Lismore Dale Co Pty Ltd ATF Miller Family Settlement

**Re: WOOLGOOGA TO BALLINA PACIFIC HIGHWAY UPGRADE, SSI-4963 :
COMMENT AND SUBMISSIONS ENVIRONMENTAL CONCERNS**

Figure 6-54 Velocity impacts 20 year ARI event: Lower Richmond River at Pimlico (North)

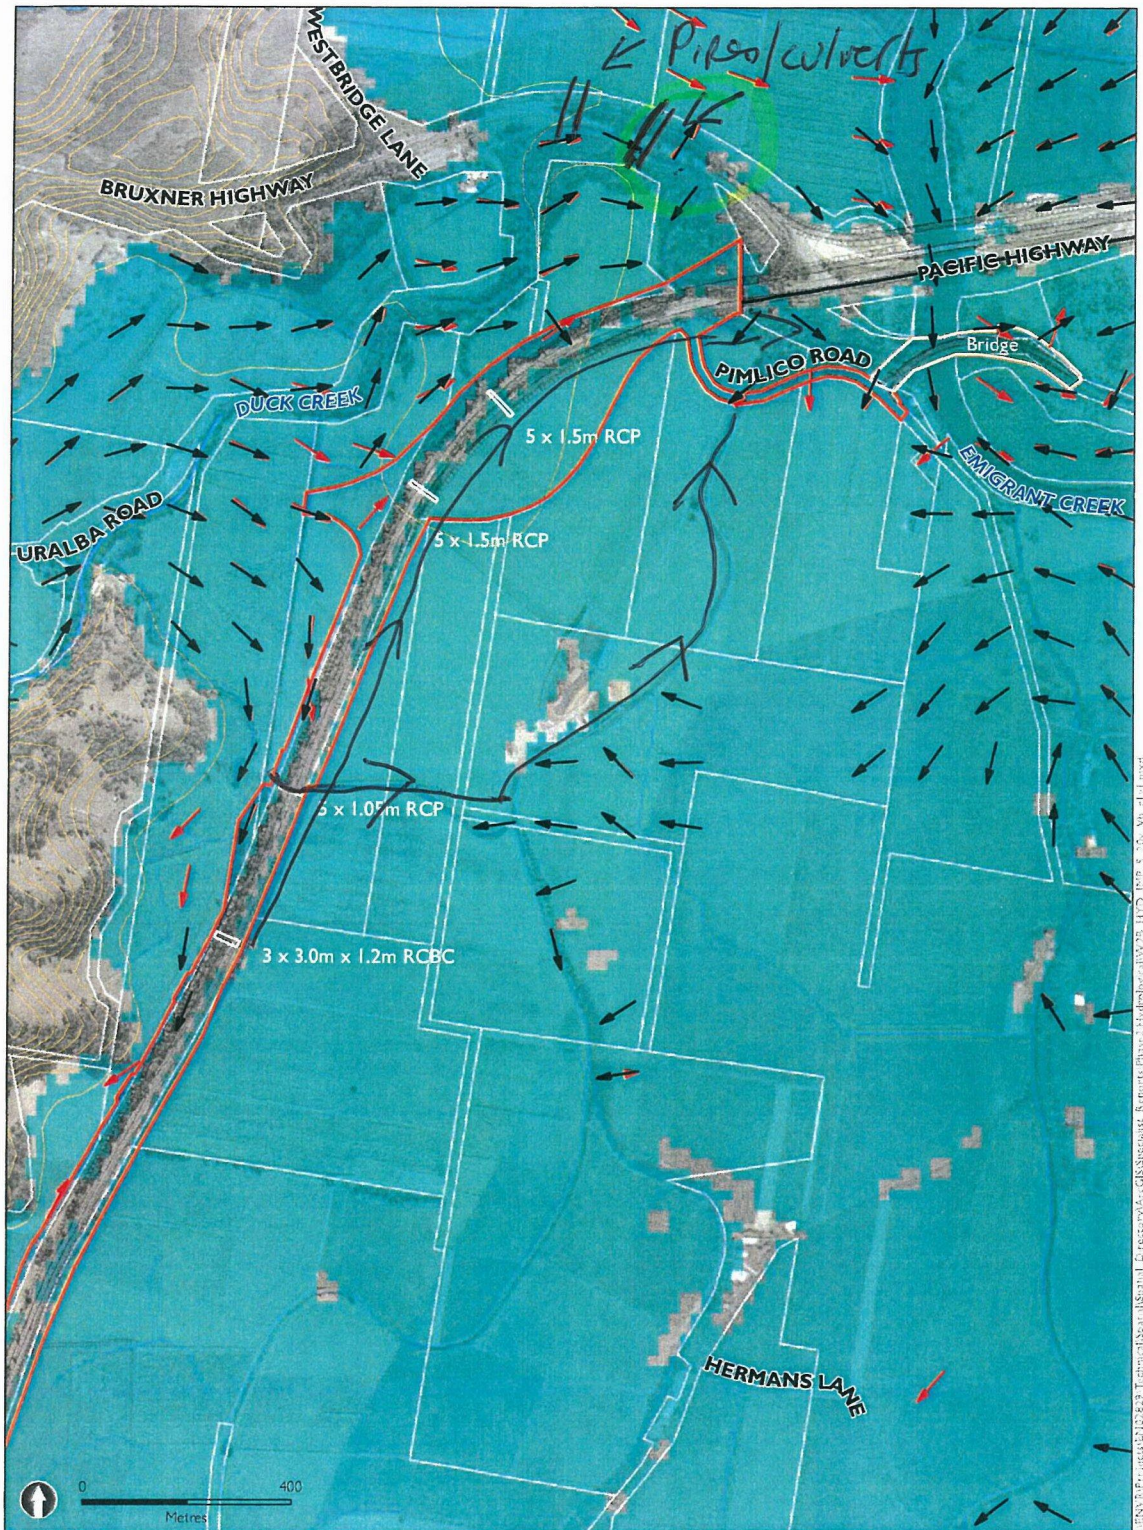
Figure 6-54 shows velocity increases on our farm

4. No indication of how large volumes of water will be dealt with once they go to the east of the highway.

Proposed solution: Undertake a survey of the land to the east of the highway and a review of the cane drains and canals there and then design and build sufficient drainage works to send the large volumes of water in a generally northerly direction working in with the fall of the land. I have penned in some suggestions on Figure 6-54 enclosed.

Figure 7-59 Flood impacts under 20 year ARI climate change scenario: Lower Richmond River and Ballina

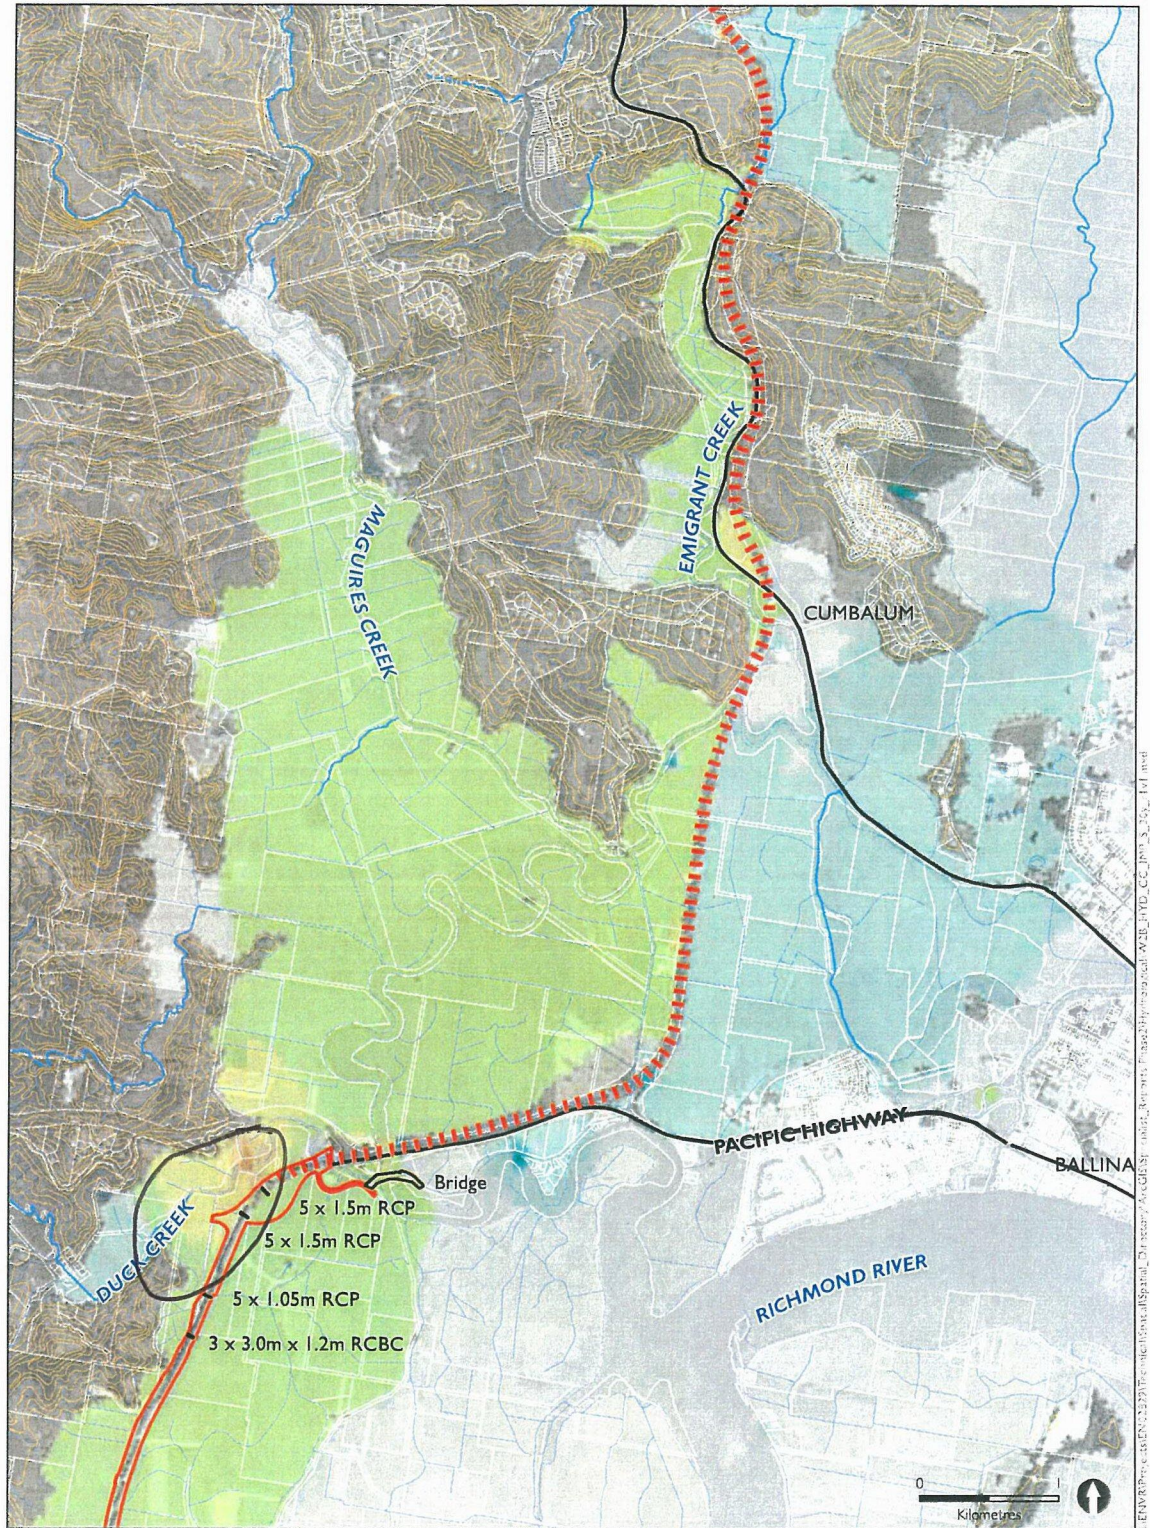
Figure 7-59 shows that our property suffers the most under a 20 year ARI climate change scenario.

Given that the height of the proposed highway is lowest in the vicinity of our property(at 1.76AHD) and this is far higher than it is currently, I welcome the culverts and piping proposed at 162.68 and 163.00 and 163.60 and 163.84, however(6.17.2 and Table 6-30). I think consideration should be given to bigger pipes particularly at 163.00 ad to the north from viewing Figure 7-59.

Major impact on our farm

Proposed solution : Large culverts and pipes under the Bruxner Highway at a reasonable depth. Consider if the action as per 6.17.2 is sufficient (and increase pipe size at 163.00 and sites north) AND put them in deeper so that water flows under the highway quicker so the duration of flooding is less. Do not proceed with the Bund proposal.
